Entergy Nuclear Generation Company  
Pilgrim Nuclear Power Station  
600 Rocky Hill Road  
Plymouth, MA 02360

Change to Applicability of Pilgrim's Pressure-Temperature Curves as Described  
in Technical Specification Figures 3.6.1, 3.6.2, and 3.6.3.

LETTER NUMBER: 2.02.021

**CHANGE TO APPLICABILITY OF PILGRIM'S  
PRESSURE-TEMPERATURE CURVES AS DESCRIBED IN  
TECHNICAL SPECIFICATION**

**PILGRIM REACTOR VESSEL PRESSURE-TEMPERATURE LIMITS  
HYDROSTATIC AND LEAK TESTS**

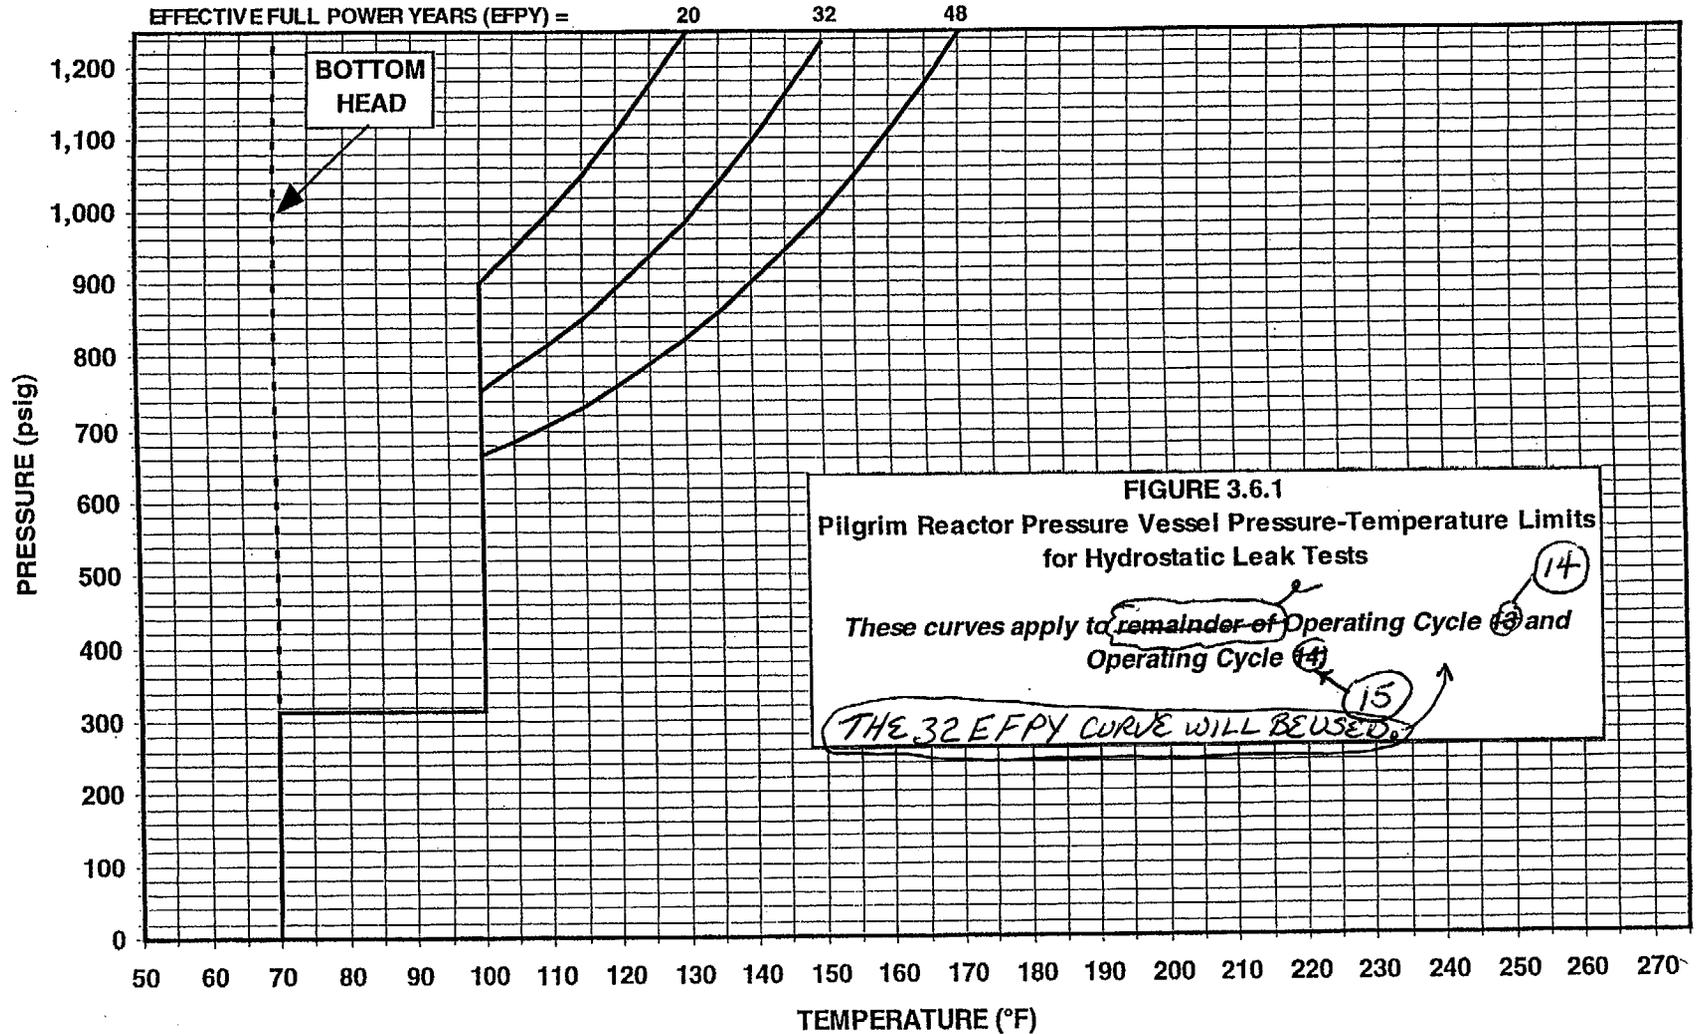
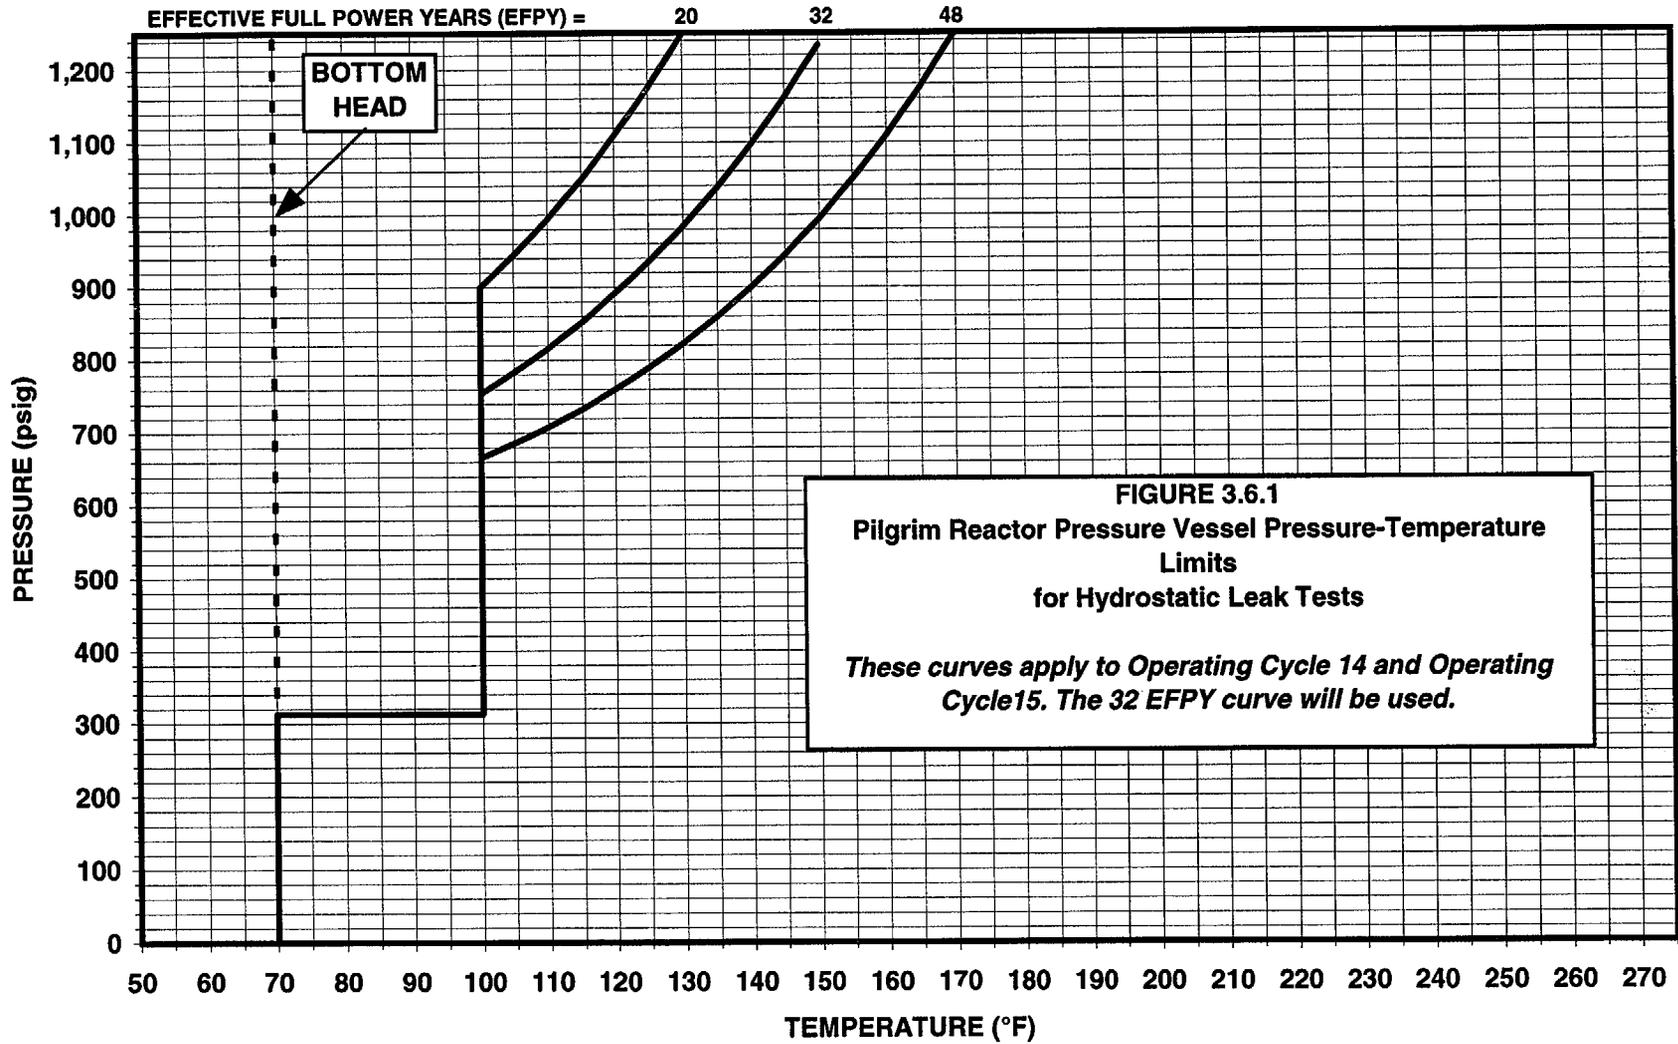
Currently, the title blocks for Figures 3.6.1, 3.6.2, and 3.6.3 contain, in part, the words:

These curves apply to remainder of Operating Cycle 13 and Operating Cycle 14.

The proposed amendment changes the words to:

These curves apply to Operating Cycle 14 and Operating Cycle 15. The 32 EFPY curve will be used.
